Our Case Number: ABP-307652-20

Re: Construction of the Boyne Greenway, pedestrian and cycleway linking Drogheda Town in Co. Louth to Mornington Village in Co. Meath
Townlands at Ship Street in Drogheda, Co. Louth to Mornington Village in Co. Meath

Construction of Boyne Greenway pedestrian and cycle way from Drogheda to Mornington

Observation on the report produced by INIS Environmental Consultants

Flock of Curlew taken from a hide on the Boyne Estuary OVL02 SPA/SAC 25th October 2022

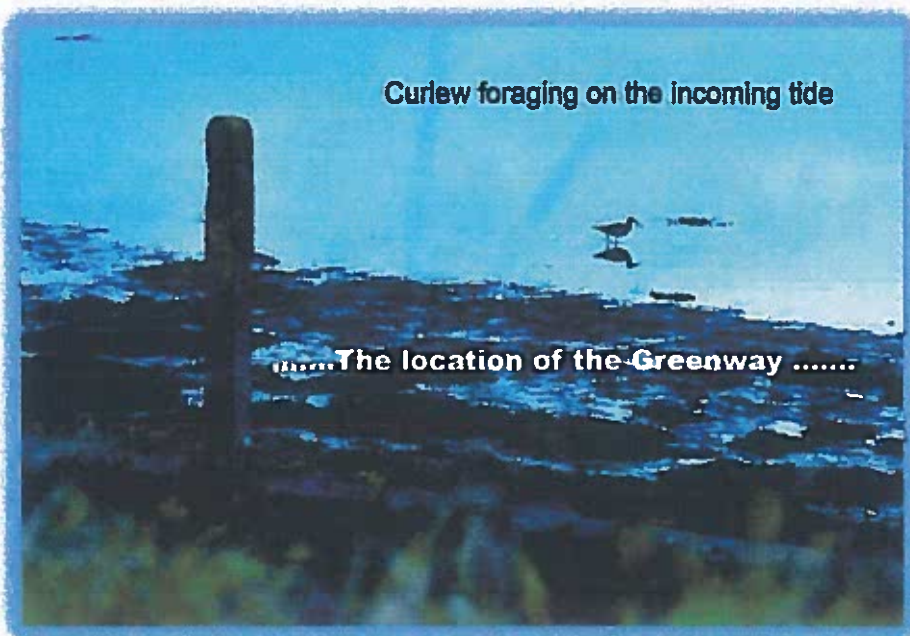
As an Bord Pleanála is in no doubt well aware, one of our most iconic birds which is on the fringes of extinction is the Curlew. I am providing photographic evidence of high numbers of Curlew on the Boyne Estuary SPA/SAC and photographs of Curlew feeding along the Estuary in the exact locations where the proposed greenway is to be constructed. The construction of this greenway will limit the feeding grounds for these and many more endangered wildfowl as the tide engulfs the Estuary twice daily. Nowhere in the NIS report was the impact of the construction of this greenway reported on the Curlew. I would have to ask the question why the plight of one of Ireland's most endangered species the Curlew was conveniently overlooked in this lengthy report.

Bar Tailed Godwits taken at location OZL03 and below photograph figure 4.5 in Inis NIS report yet there was no mention of any Bar Tailed godwits in any of their counts .

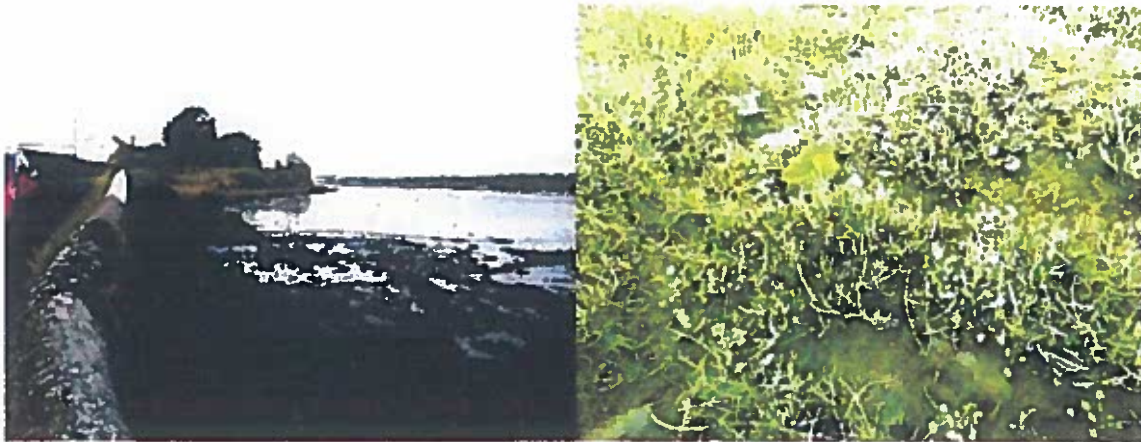
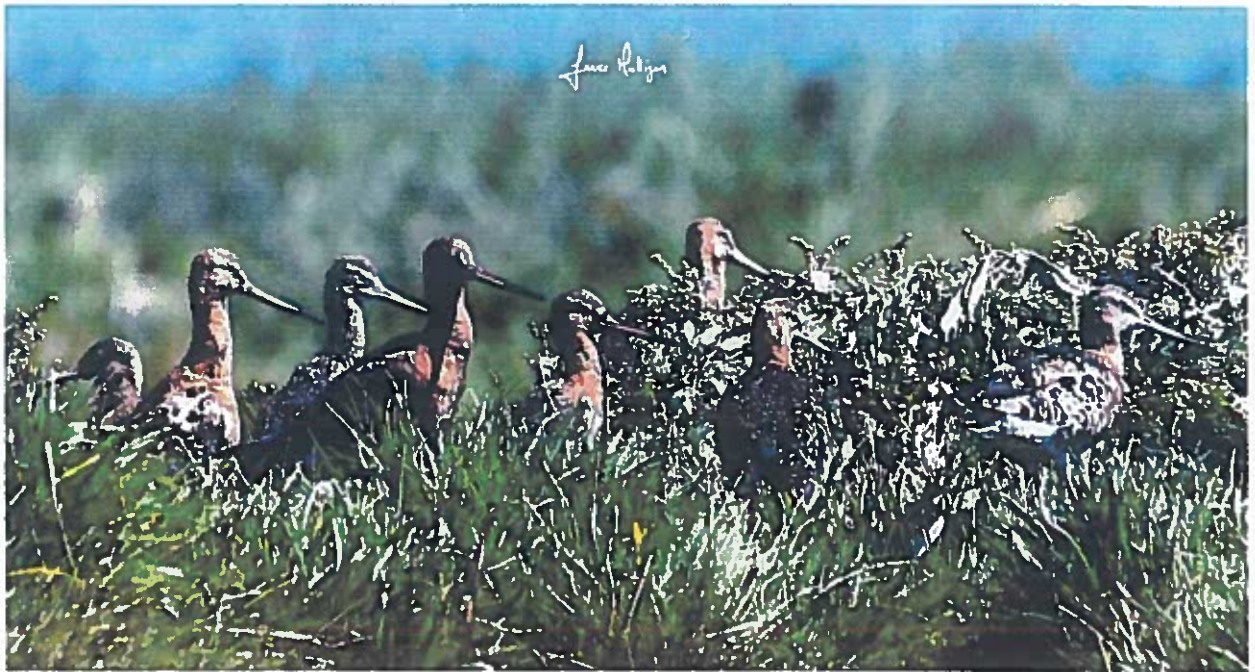
The photos below were submitted by INIS of the Boyne Estuary at Mornington bridge .The photos clearly show that the terrain is unsuitable for walkers and contradicts the conclusion of the benefits of a walkway to help with the hordes of walkers in this area at present !! Meath County Council propose to build a bridge adjacent to this bridge and I have submitted a photo below of flocks of lapwing as well as many other birds that use the stream flowing under this bridge to wash and drink which will no longer be used on the commencement of construction of a pedestrian bridge on that stream.

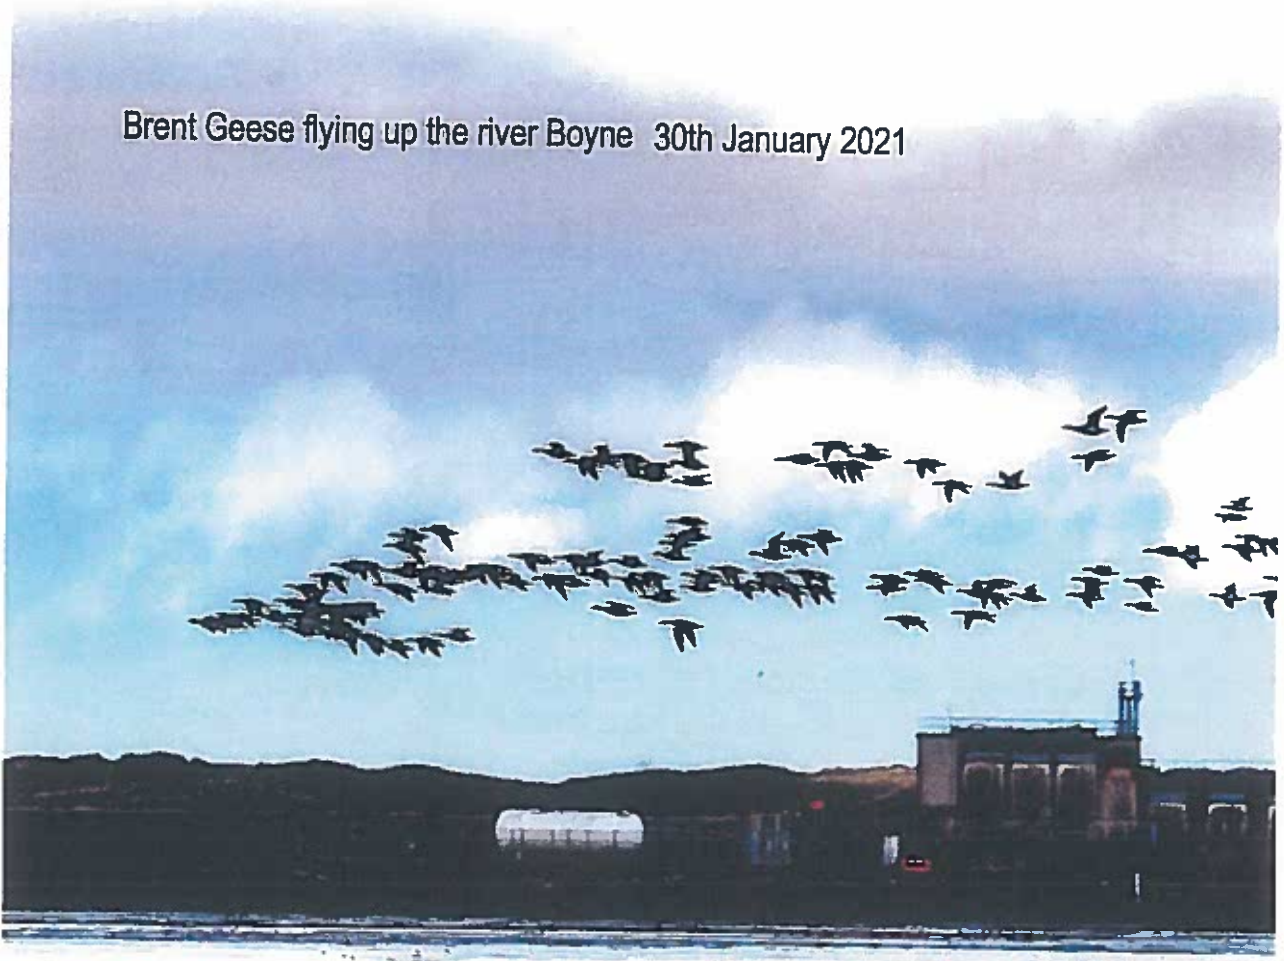
Their own photographic evidence clearly show no similarities whatsoever to the Greenway being proposed for the Boyne Estuary .The greenways highlighted in this report all show buffer zones i.e railway lines ,roads ,hedges etc... between the paths and the rivers and at no stage enter or encroach any protected . The greenway proposed for the Boyne Estuary *enters* the SAC/SPA for the majority of the route .

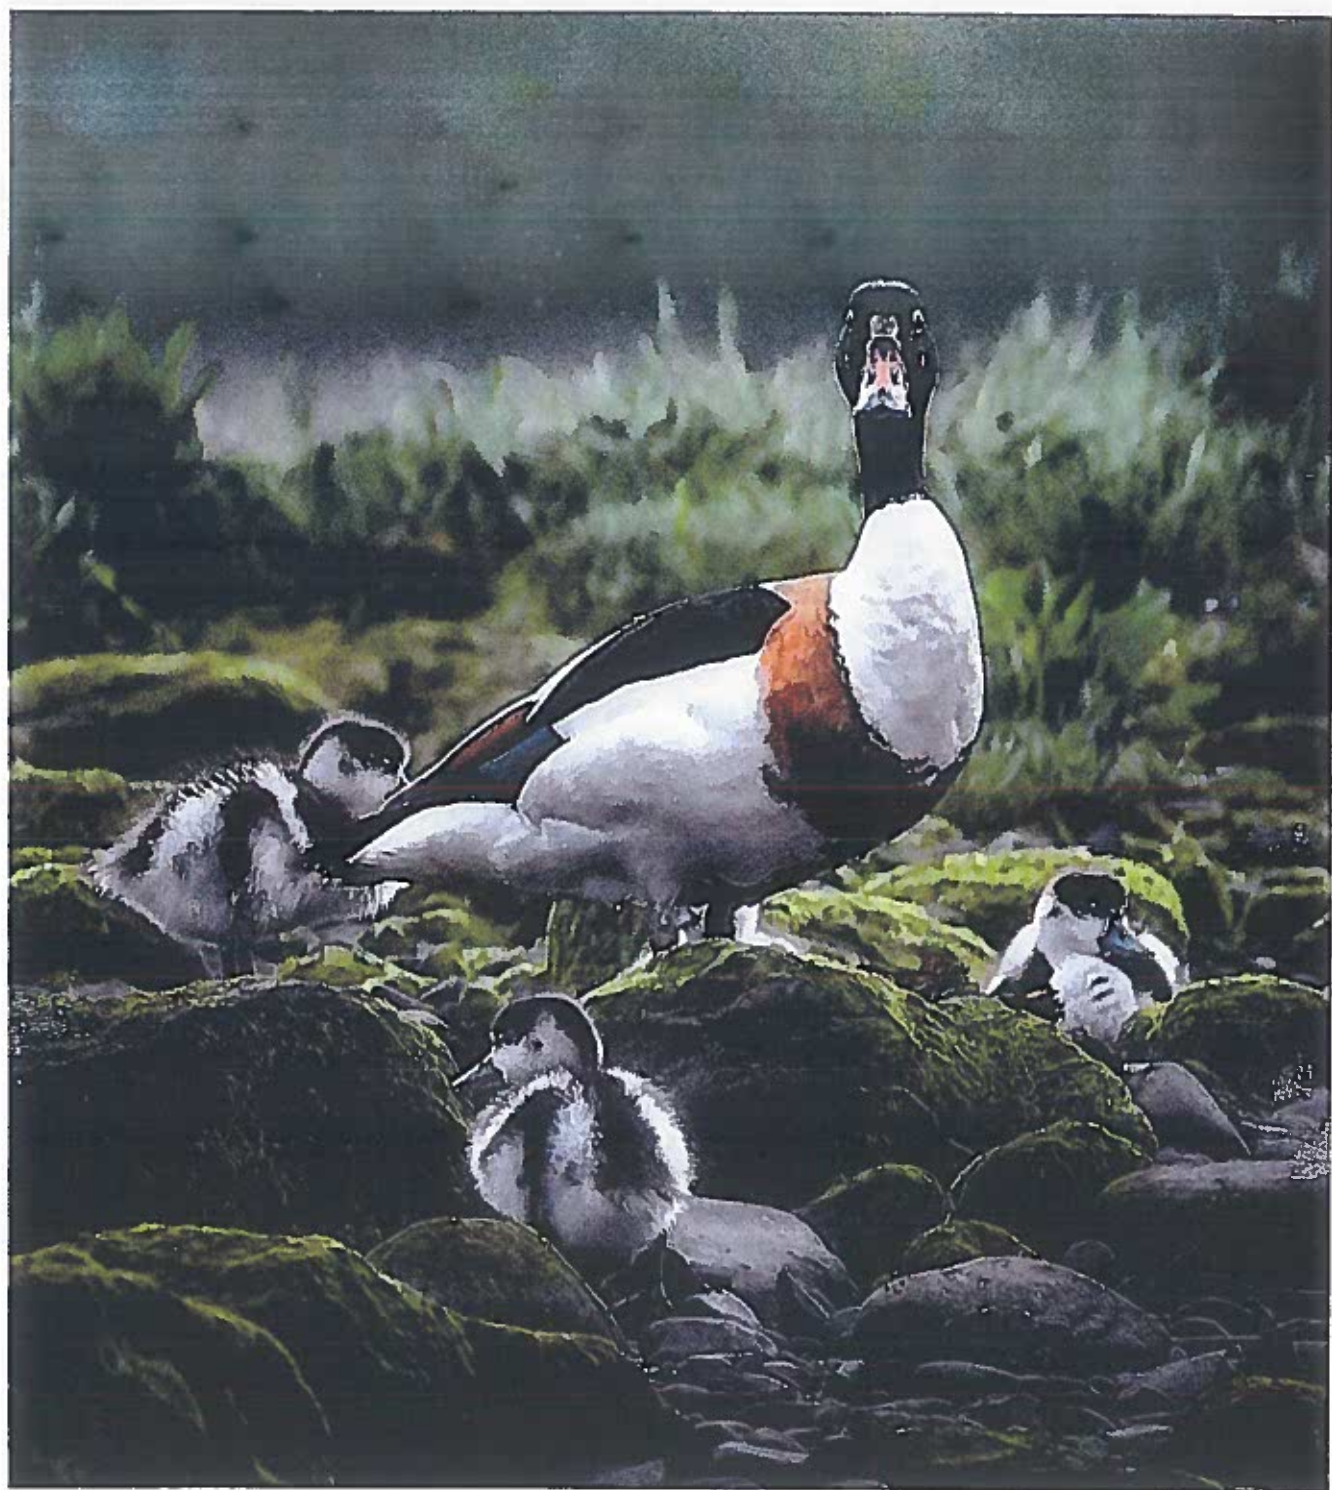
The proposed Greenway is going to exit onto an EU protected SAC at Mornington Dunes .This is area of national importance and sensitivity and is currently being scrutinised by the NPWS who are in talks with Meath County Council as to reverse the damage that has been caused to this area due to the neglect of the said County Council.

By exiting this walkway onto an E.U protected site there is no way of stopping people straying and causing irrevocable damage to this area of sensitivity , this NIS report has failed to address these issues .
